# Planning Objection Report

Third Party Planning Objection Report in respect of Wicklow County Council planning application, reg. ref. 22380. The proposed development comprises of: "42 no. residential units comprising - 20 no. 1-bed apartments, 20 no. 2 bed (4 person) apartments, Works to Stylebawn house to provide a 4 bed house, Works to the Gardeners Cottage to provide a 2 bed house. The proposed apartments are provided in a single 5 storey block comprising a basement level, lower and upper ground floors and first and second floors. The apartments are provided with private and communal amenity spaces. Access is provided from the Glen Road (R762) generally in the location of the existing access, with a new entrance arrangement proposed with associated boundary works. Demolitions and site clearance are proposed to facilitate the development. All associated site development works including landscaping, internal roads, utilities, water infrastructure and construction phases works and development" at Stylebawn House, Delgany, Co. Wicklow.

This Planning Observation Report has been produced by BPS Planning Consultants Ltd for and on behalf of Delgany Community Council C/O Paul Armstro

Fig. 9: The area of the site occupied by the apartment scheme is 0.7664 ha. in size

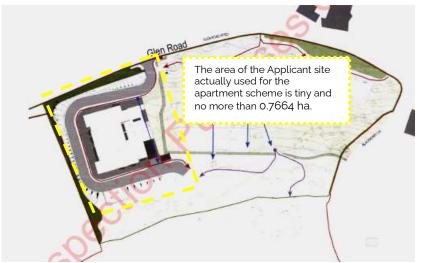
BPS considers that this figure of 52 uph is the appropriate one for the assessment of density as it pertains to the area of the site where new residential development is proposed. Stylebawn House forms no part of the area of the site within which the apartment scheme is proposed. It is little more than a prop to the actual scheme and a prop used to dilute the actual scheme density. This density is wholly at odds with the LAP and with national planning policy and guidance.

The Applicant's proposed plot ratio for the area of the site proposed to contain just the apartment scheme is 1.445. This is based on the area of the site given over to the apartments provided in the Applicant Planning Report which is 0.7664ha. divided by the 5303sq.m of gross floor area proposed.

Fig. 10: Zonings of Applicant site under the Greystones -Delgany and Kilcoole LAP 2013-2019

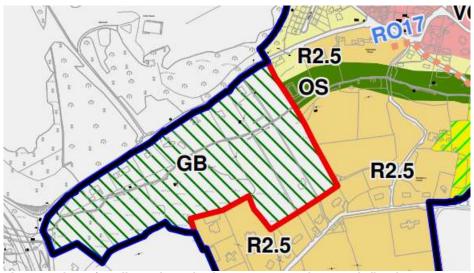
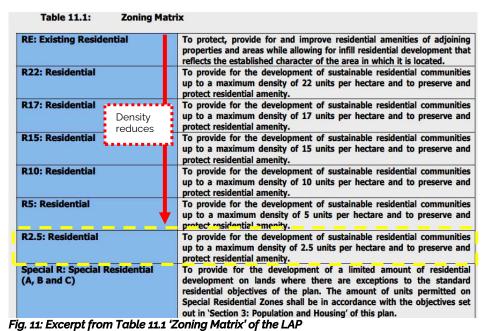
The proposed development therefore represents a material contravention of the zoning objective pertaining to this site. Our client objects to this and submits that this planning application cannot be granted in these circumstances. Para. 4.30 of the Applicant Planning Report states: "The proposal therefore exceeds the 2.5 units per hectares specified in the LAP". Our client objects to the Applicant setting out a scheme which knowingly and deliberately ignores the adopted Local Area Plan in place for this area.

Fig. 12: Clara House sited within the steep section of the site

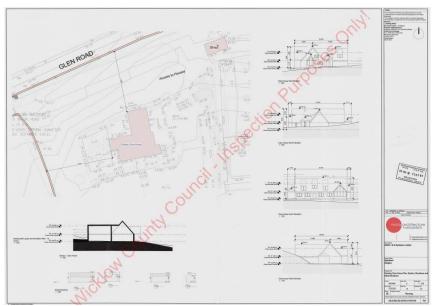
Clara House should not be replaced by an apartment block.

Fig. 15: Excerpt from the Daylight and Sunlight Report

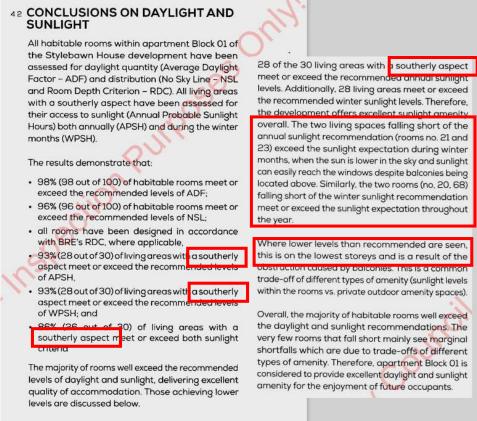
It is unclear how the assessor reached the conclusion that the daylight and sunlight performance of the scheme is "excellent" when multiple units are wholly compromised insofar as sunlight is concerned. The assessor might comment on the primarily north facing single aspect units and those at Lower

A qualitative review of this scheme confirms the living environment for many residents would be intolerable insofar as access to sunlight matters. They would be using electric lights all year around.

By way of conclusion and to try to justify the poor sunlight that many residents would receive, the report refers to Average Daylight Factor. BPS notes how discussions around average daylight factor are very controversial as averages can hide many problems (Dublin City Council's Draft CDP states that ADF cannot be used to assess overshadowing impacts on adjoining and surrounding areas. No averages should be allowed to be applied in this case.

Fig. 16: Lower Ground Floor - below ground units

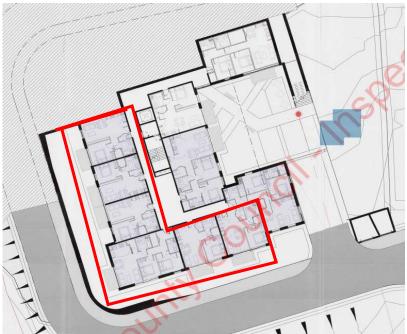
No less than 10 units are provided at Lower Ground Floor Level. While it is acknowledged that the site slopes, many of the residents sited at Lower Ground Level, especially those without dual aspect, will experience a compromised environment.

Many of these units would receive poor light, poor views and poor amenity.

Fig. 19A: The scale of the proposed basement to be cut into the existing slope

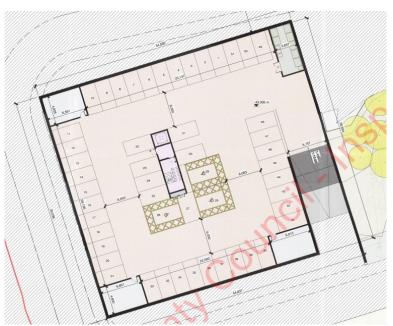
The very steep topography of the site will require extensive earthworks to bring roads and structures to within approved gradients and will necessitate extensive regrading of the site in effected areas. The development of lands associated with Clare House face similar challenges in terms of designing buildings and infrastructure on a steeply sloping site [emphasis added].

The Applicant sets out proposals which effectively argue that they should be permitted to completely reconfigure this area of the site. That it is an inevitable short term impact which can be mitigated. Our client does not agree. The extent of work proposed to the landscape at this location cannot be justified.

Fig. 27: Internal uphill cycle route - slope is all uphill to the road

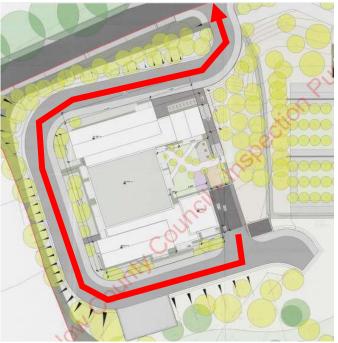
Any person on a bike would then reach the public road where there is no cycle lanes and which is well known as being unsuitable for cycling along due to its restricted width and the speeds of vehicles along the road.

Cyclists turning right from the entrance and towards the village and possibly Greystones would need to cross a lane of oncoming traffic.

Fig. 28 - Road improvements required and Tree Loss

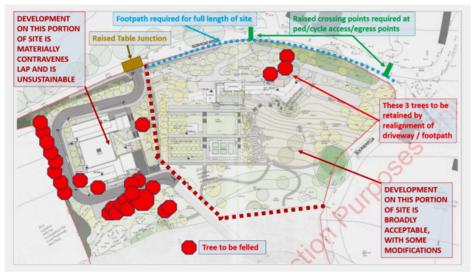
- 1. a new footpath should be provided along the R762 Glen Road for the full length of the site;
- 2. raised crossing points should be provided to allow pedestrians and to cross the R762 safely;
- 3. a raised table junction should be provided for any new junction; and
- 4. the three trees to be felled should be retained by a minor change to the driveway / footpath.

The scheme cannot reasonably progress without these revisions.
